US-APWR

Discussion on Non-safety Automatic Control Signals to Safety Related functions

Response to 07.09-24 (RAI 778-5866)

Figure 1 (a)
Example of Control Logic for
Letdown Orifice Isolation Valve

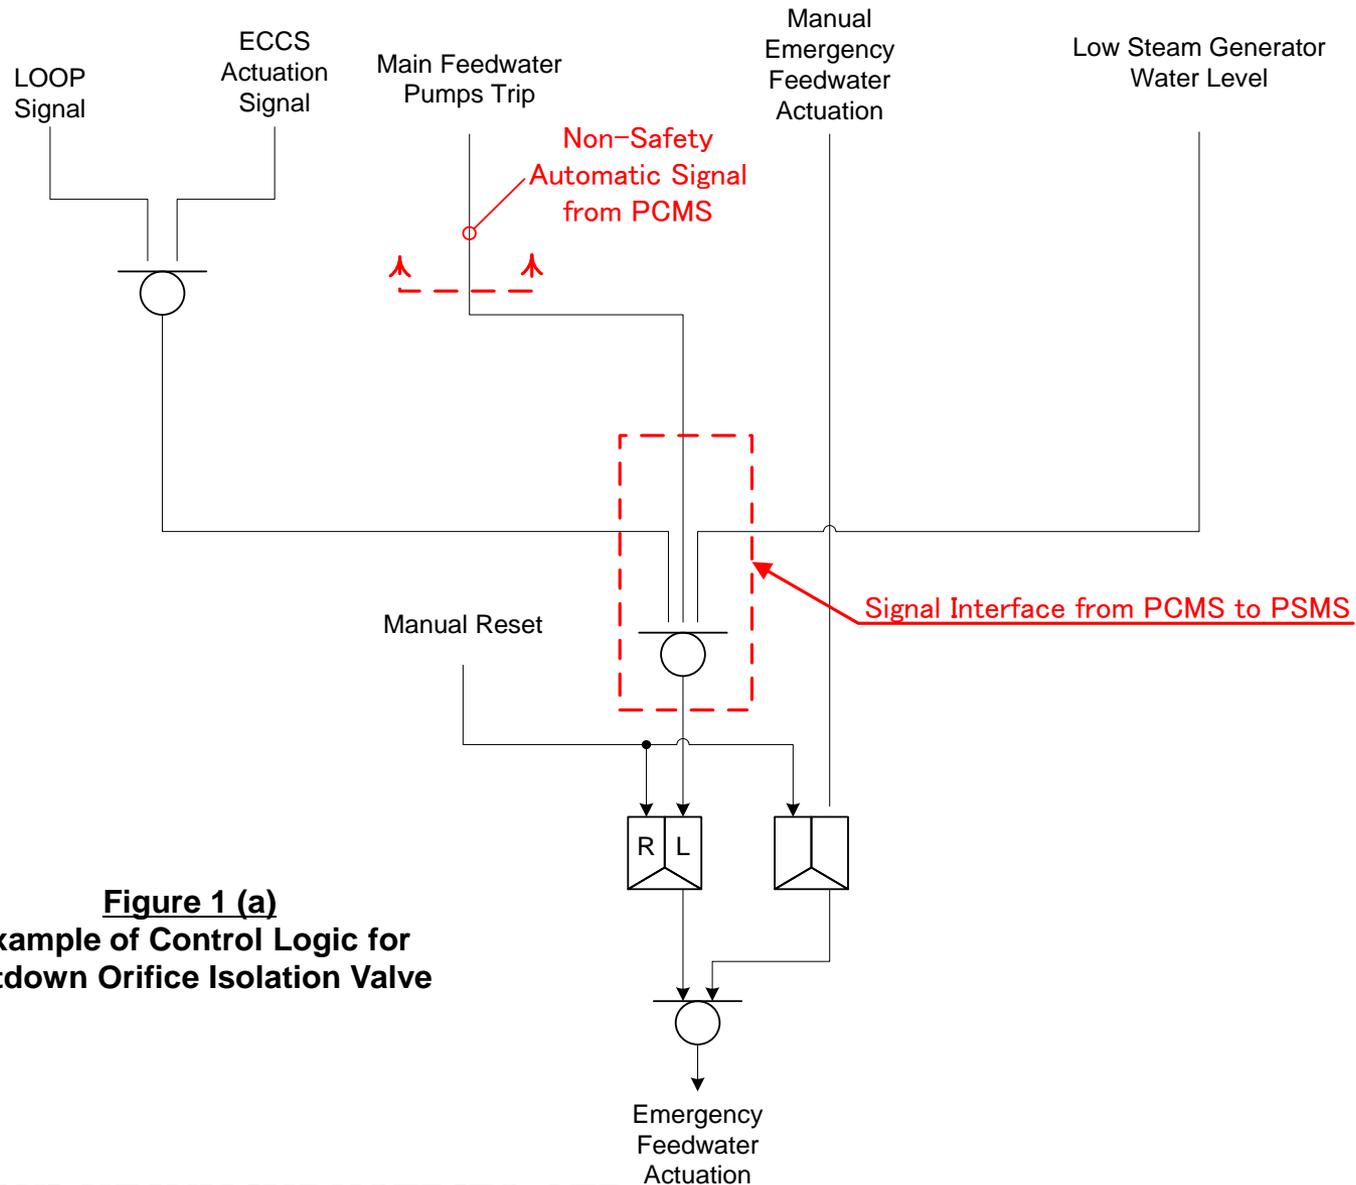
- The interface logics for the non-safety automatic control signals from the PCMS consist of simple “AND” and “OR” logic functions within the PSMS, as shown typically in Figures 1 (a) and (b), below. Therefore, the added complexity for these additional signals and logic functions in the PSMS is very limited. In all cases, safety-related signals in the PSMS have priority over these non-safety automatic control signals from the PCMS.

- If the non-safety automatic control signals from the PCMS to the PSMS are interfaced by hardwired cables, the “AND” and “OR” logic functions shown in Figures 1 (a) and (b) are still needed in the PSMS. In addition, for the hardwired cables interface design must require additional hardware devices in the PSMS, such as, binary I/O modules, isolation modules, etc.

- On the other hand, the Unit Bus interface can minimize the hardware devices and reduce the complexity of the system architecture of the PSMS, to compare with the hardwired cables interface because the Unit Bus interface does not require any additional hardware devices. Therefore, the Unit Bus interface results in the simplest architecture of the PSMS, as complying with the guidance of ISG-04, Staff Position 1.3.

The interface logics for the non-safety automatic control signals from the PCMS consist of simple “AND” and “OR” logic functions (within the PSMS). Therefore, the added complexity for these additional signals and logic functions in the PSMS is very limited. In all cases, safety-related signals in the PSMS have priority over these non-safety signals from the PCMS.
